20 HEATHER DR

ARB REVIEW COPY

RE: Tree Inspection of 20 Heather Dr. East Hills, NY 11576

**Evaluation of trees tagged for removal at the Alder residence,
20 Heather Drive, East Hills, NY**

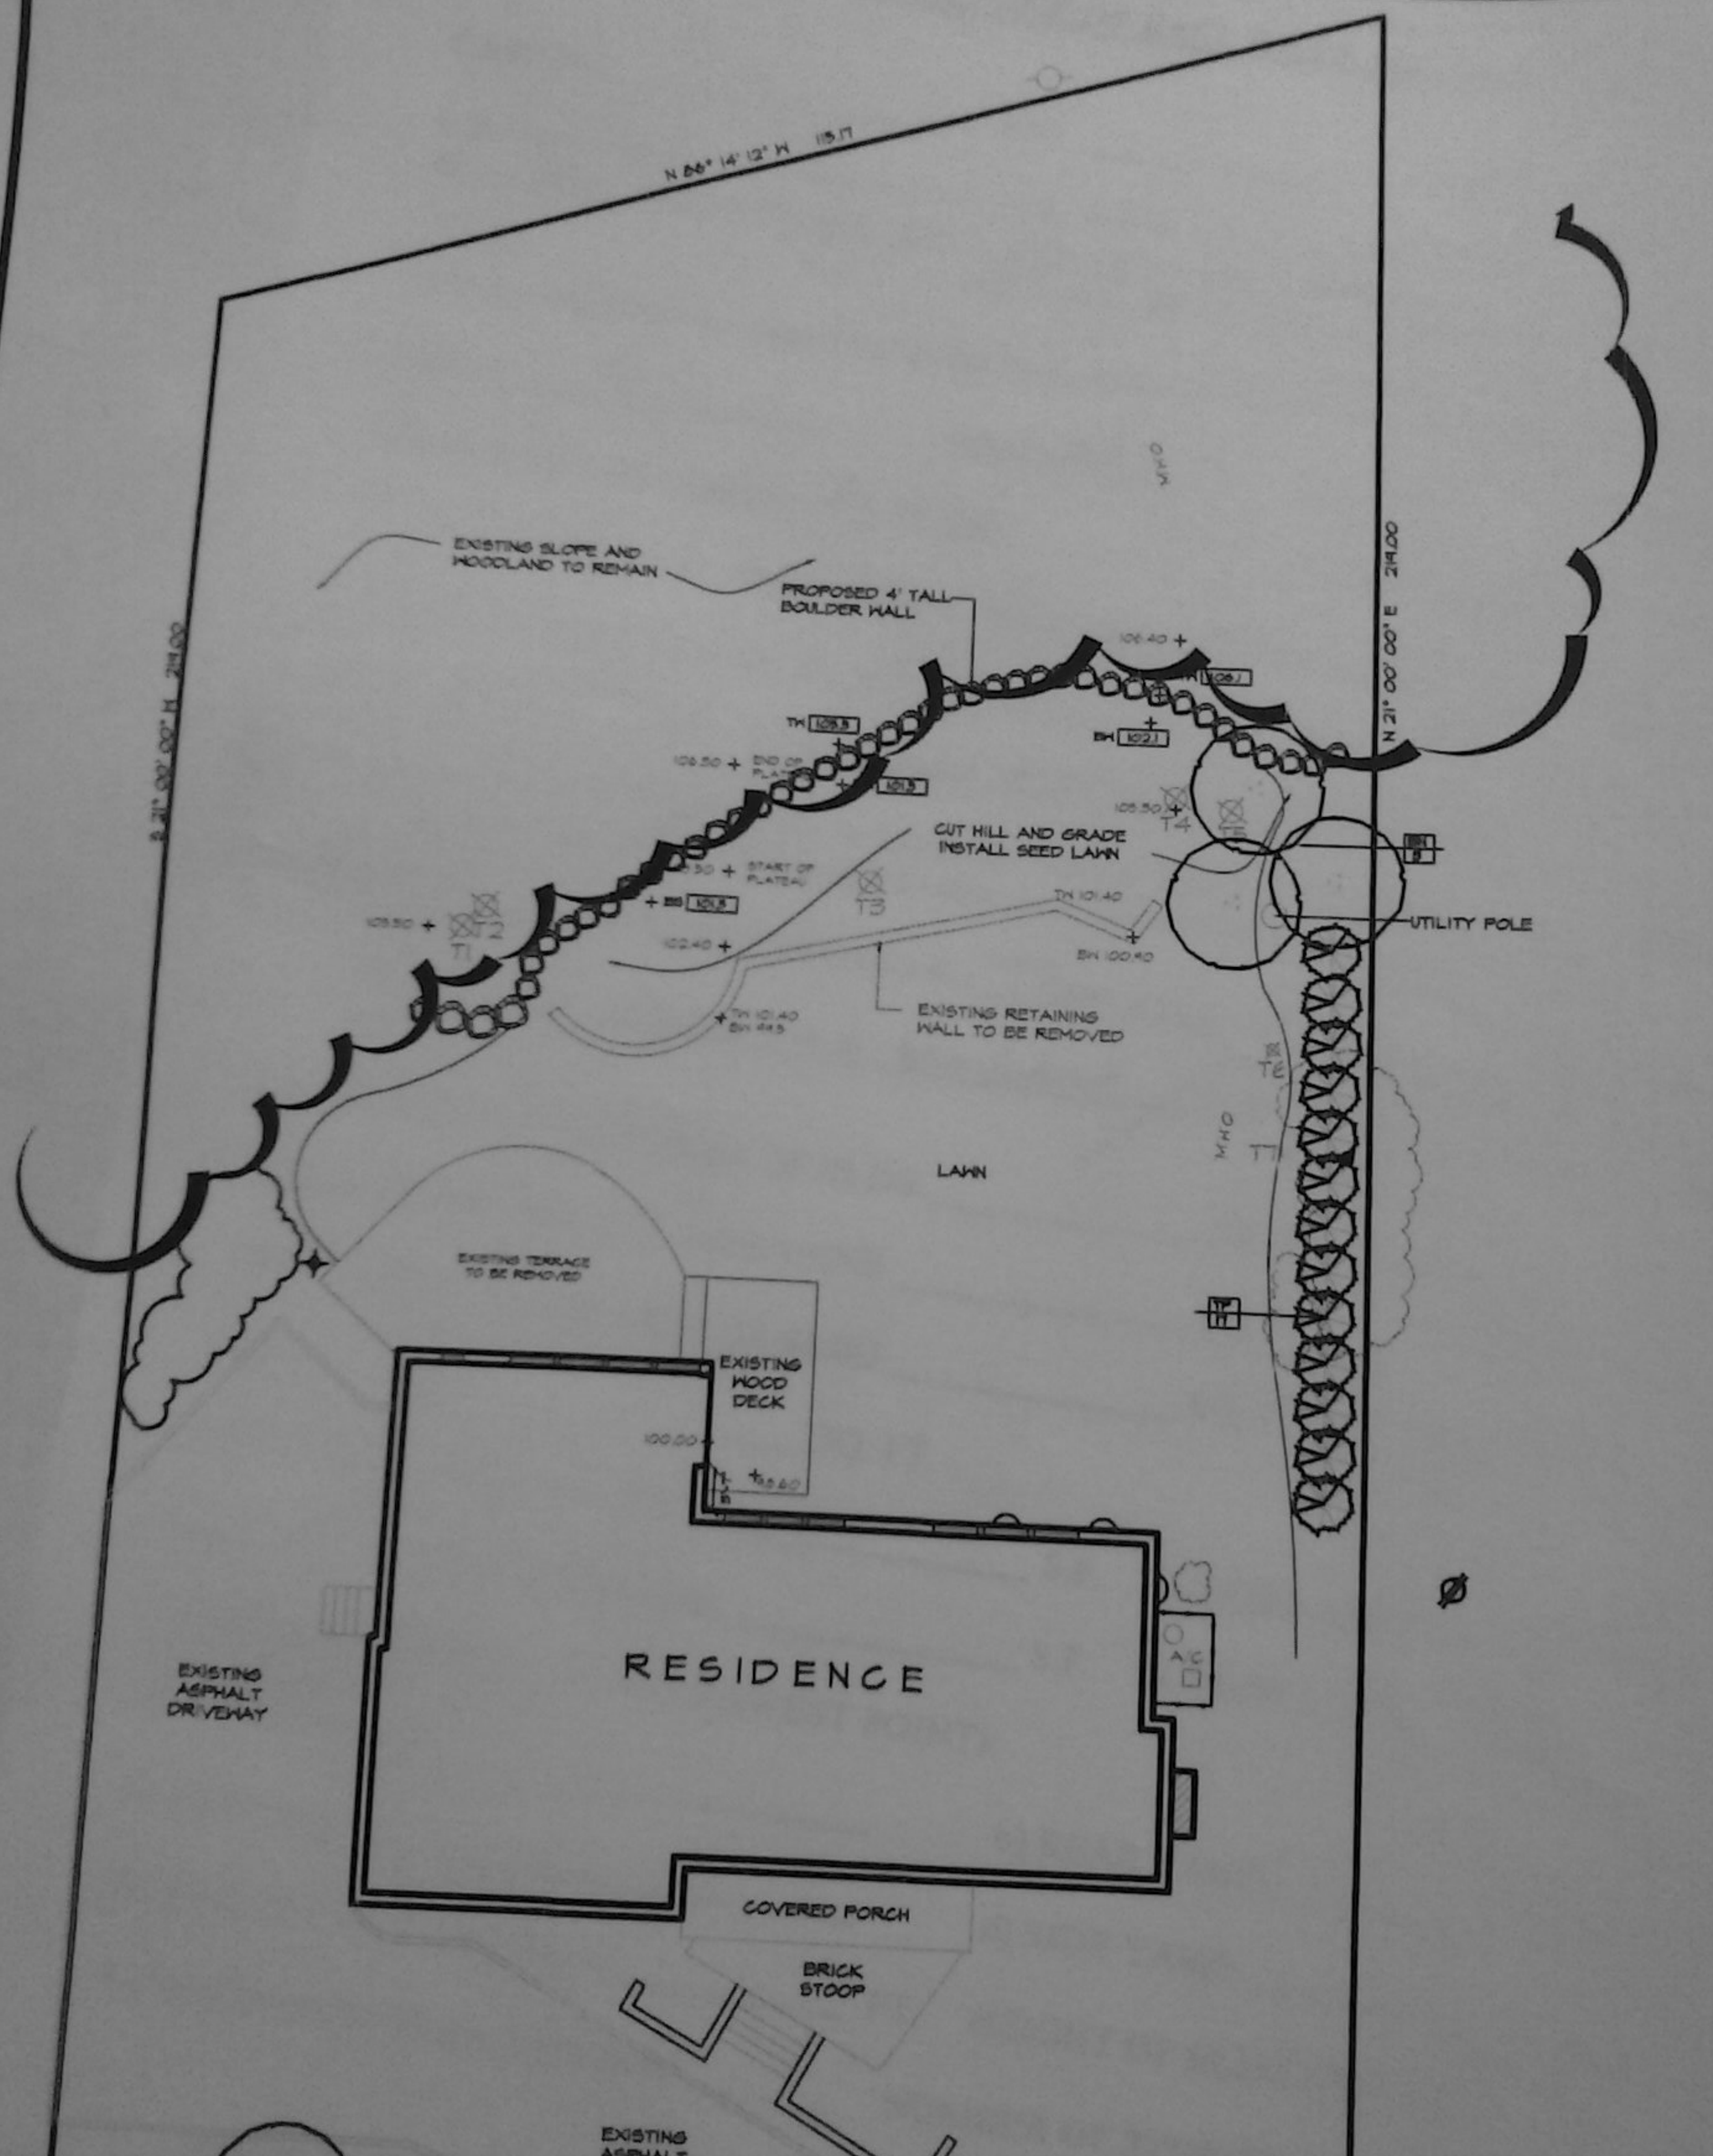
As per your request, I inspected the trees to be removed and reviewed the landscape plan for Heather Dr. If the village approves the landscape plan to install a boulder wall and the hillside, allow more lawn area then all of these trees should be removed.

None of these trees are specimens. The ailanthus trees are invasive weeds.

The wild black cherry tree (referred to as a linden on the application) has been improperly treated over the years and is permanently damaged.

The trees along the back are long trunked trees with small canopies and poor trunk taper, making them competing for light earlier in their life. They are relatively healthy but not ideal landscape trees.

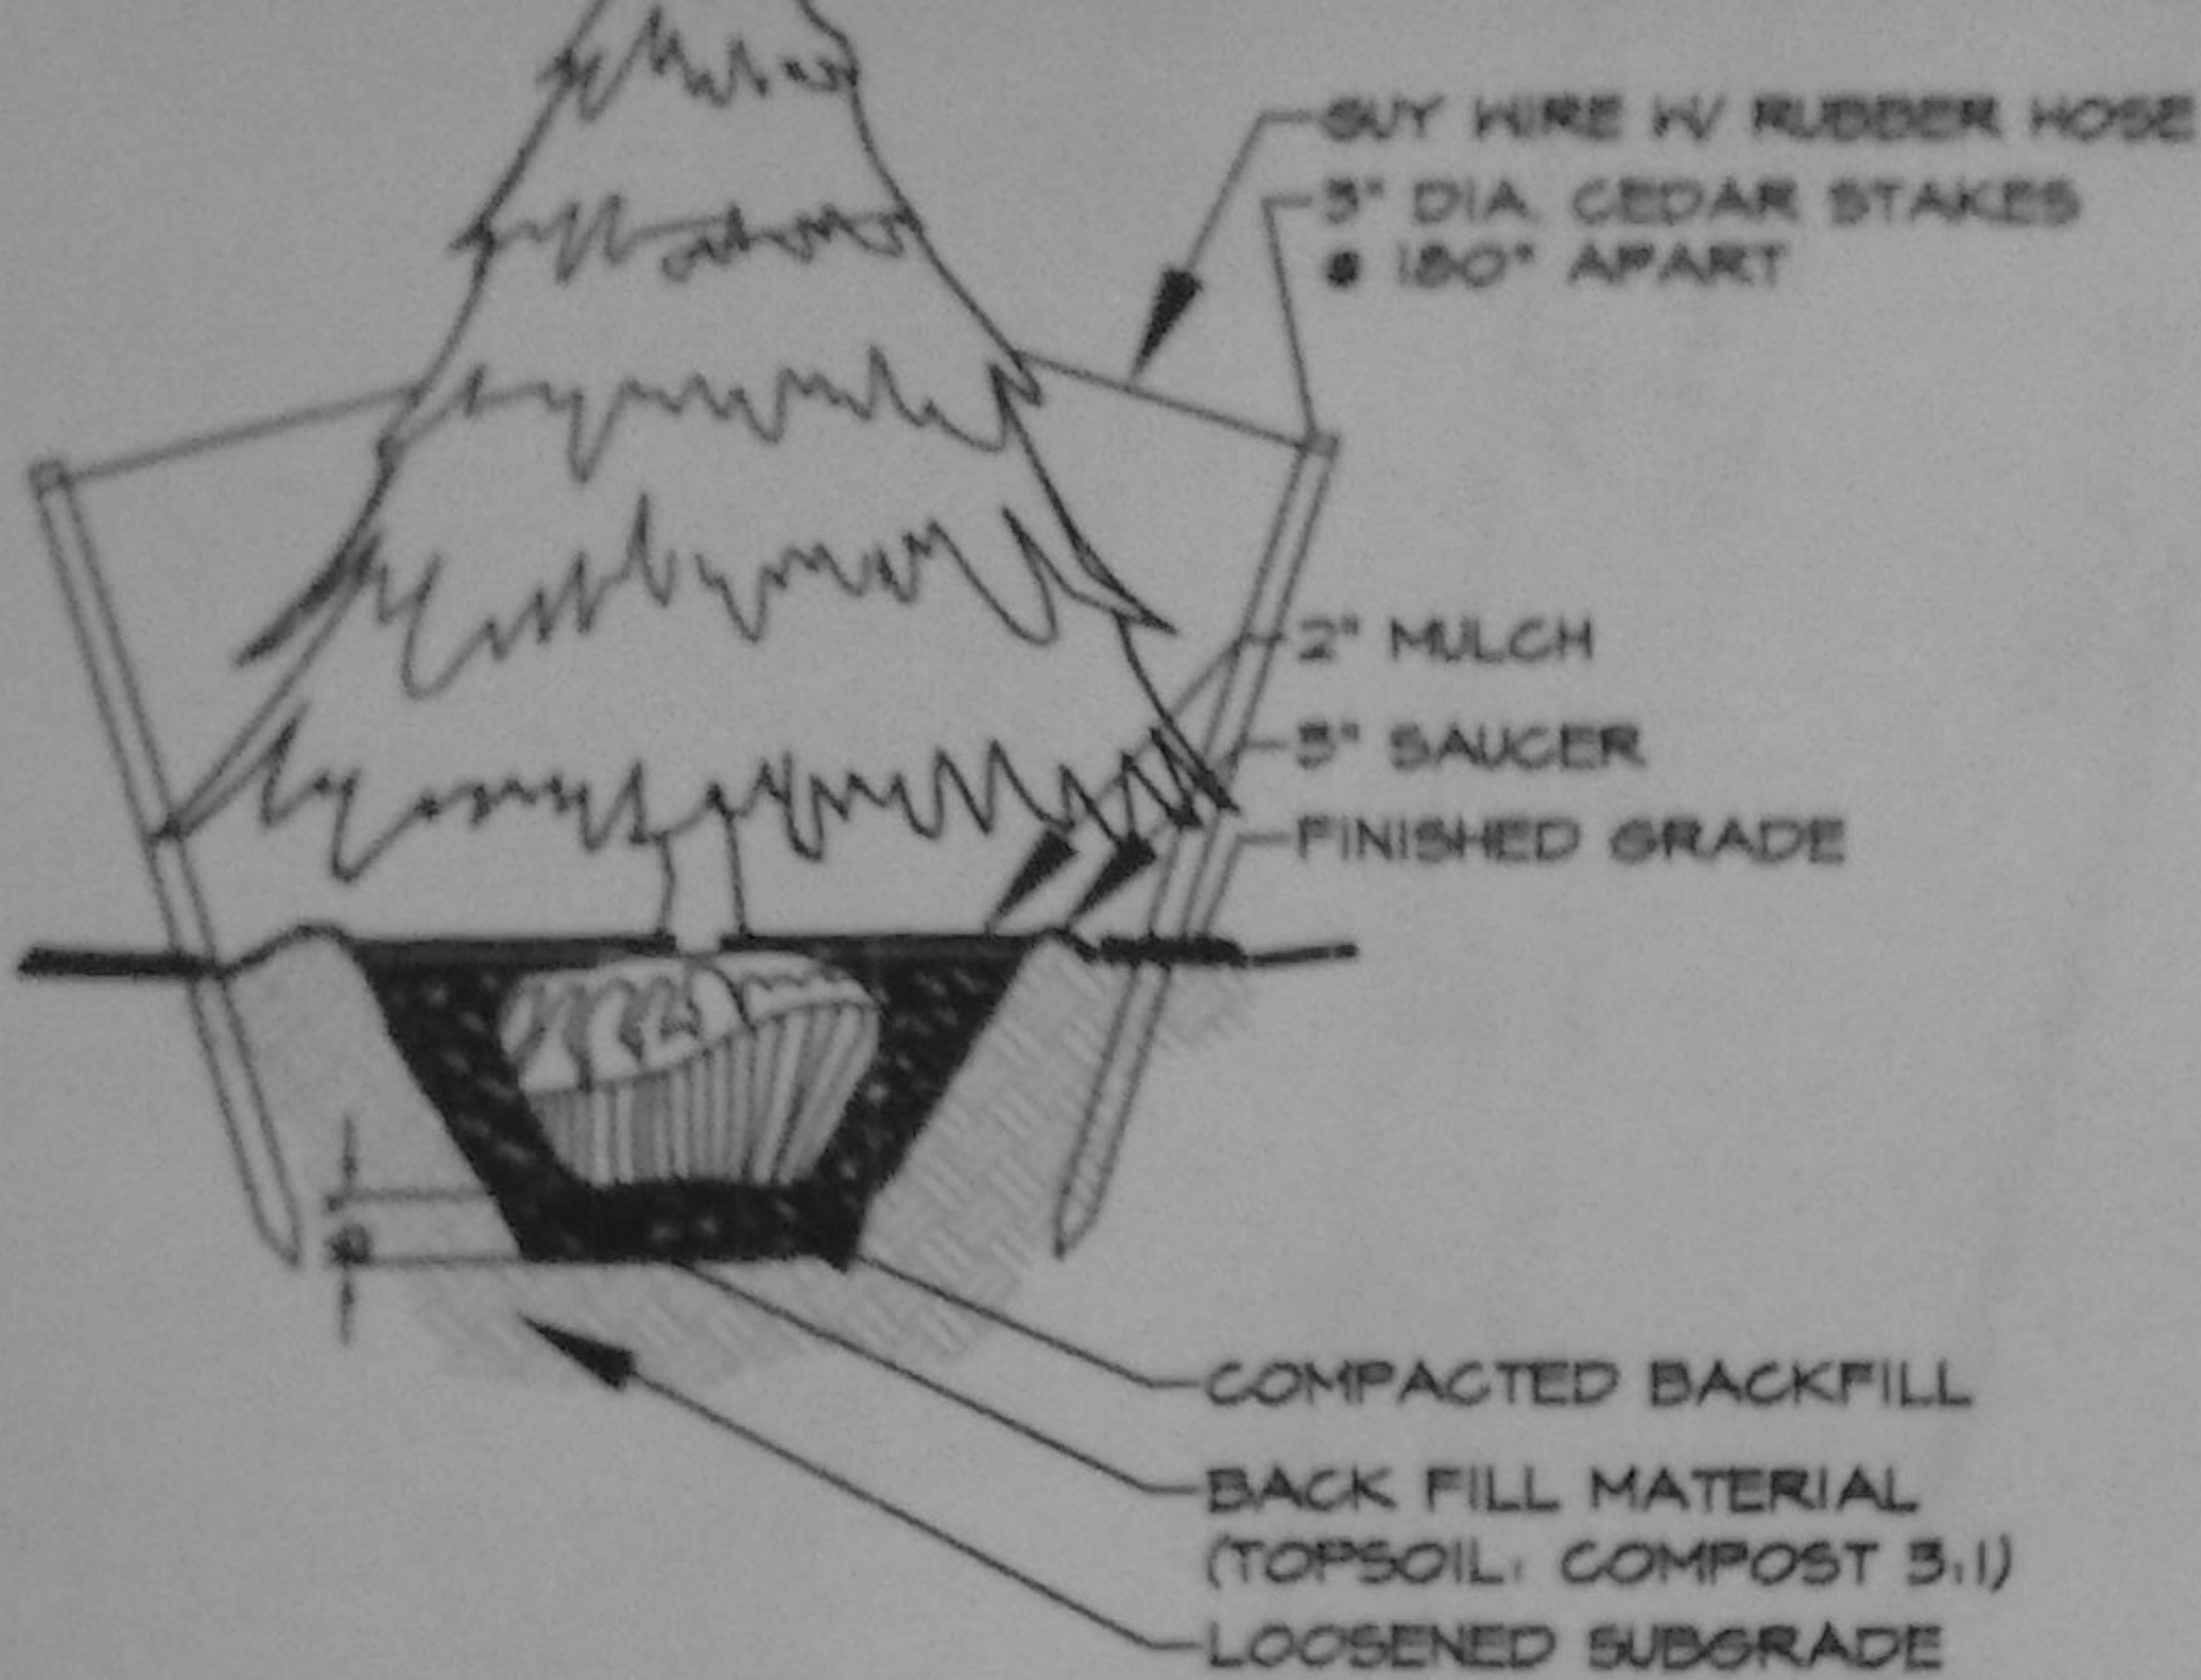
These trees would be in the way of the proposed re-grading and would not survive the proposed work. Several of these trees are compromised by various conditions noted above and poses a potential hazard from failure. I would recommend removal of these trees as soon as practically possible to eliminate the potential hazards.

The removal of these less desirable trees will allow more air circulation and light for the other trees on the property and adjacent properties to prosper.

If additional trees are to be planted, the selection of better types (species/varieties) and proper planting after the regrading is done is recommended.
